## **Public Improvement Variance – Rice Road Park**

**TO: Matthews Planning Board Members**  
**DATE: June 19, 2018**  
**FROM: Mary Jo Gollnitz, Planner**

**Public Improvement Variance:** Variance request related to public improvements along Rice Road associated with Rice Road Park Project

## Rice Road Park and Road Expansion

## EXHIBIT 1

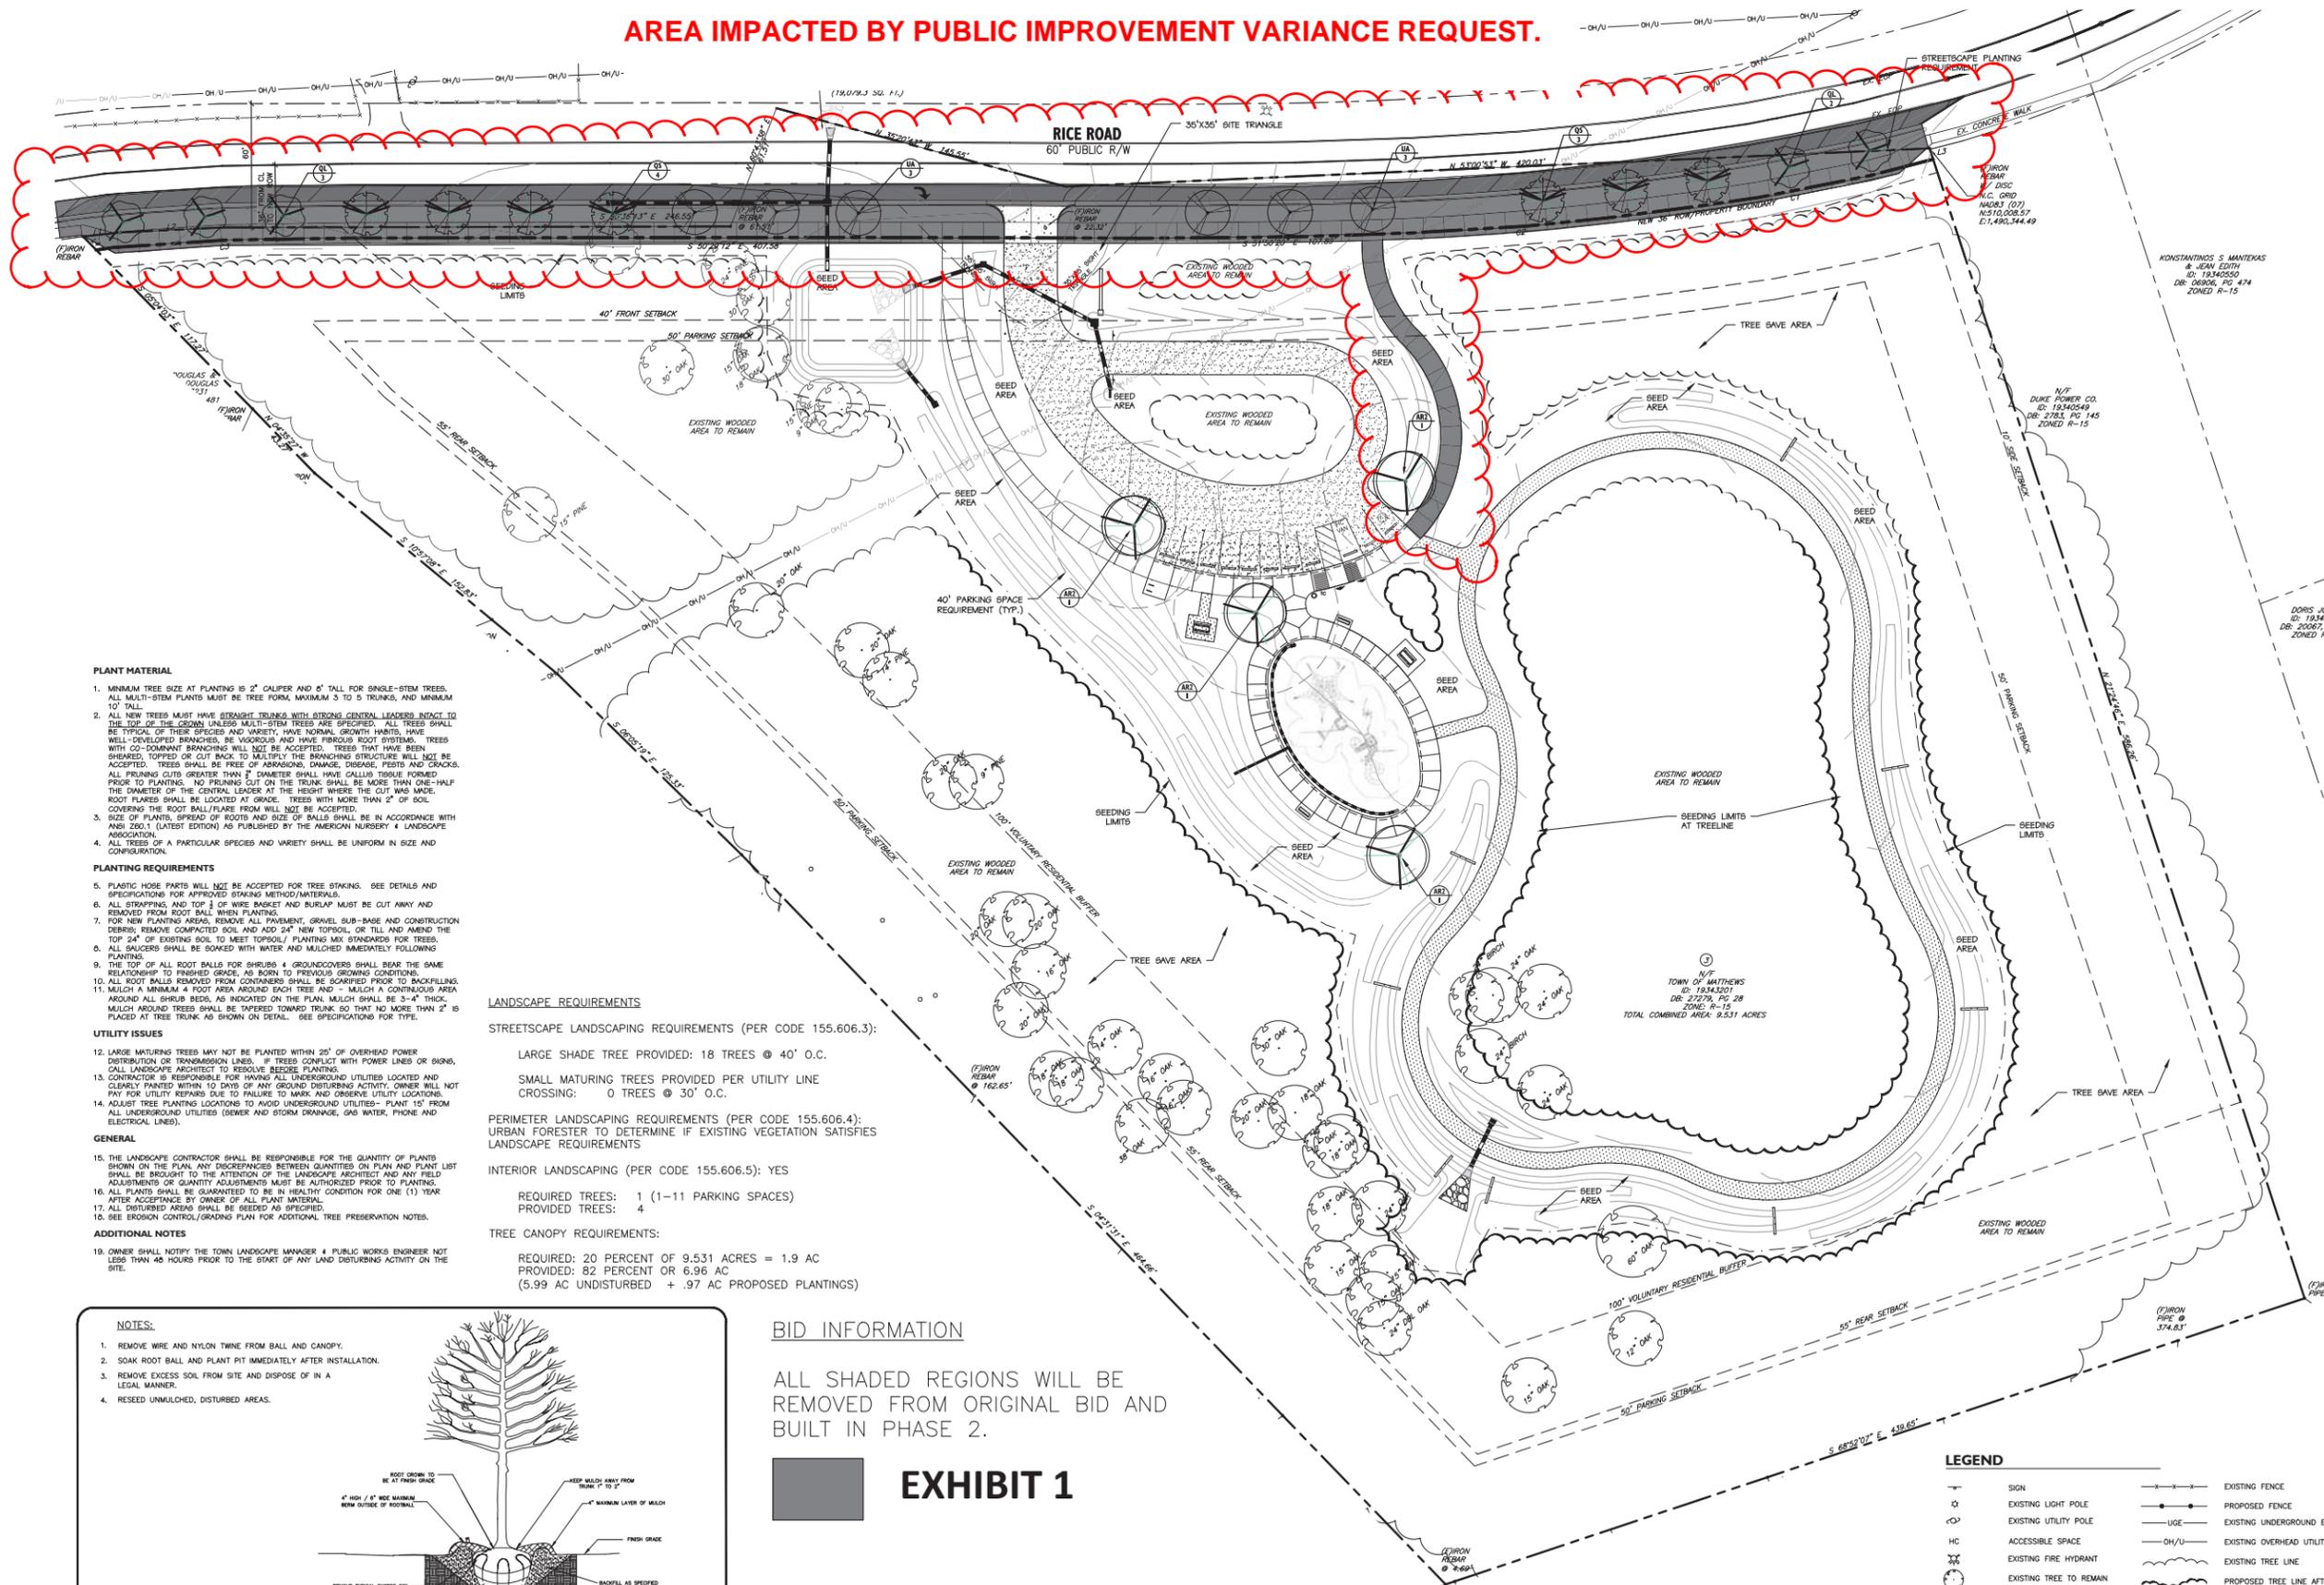
# AREA IMPACTED BY PUBLIC IMPROVEMENT VARIANCE REQUEST.

ALL SHADED REGIONS WILL BE REMOVED FROM ORIGINAL BID AND BUILT IN PHASE 2.
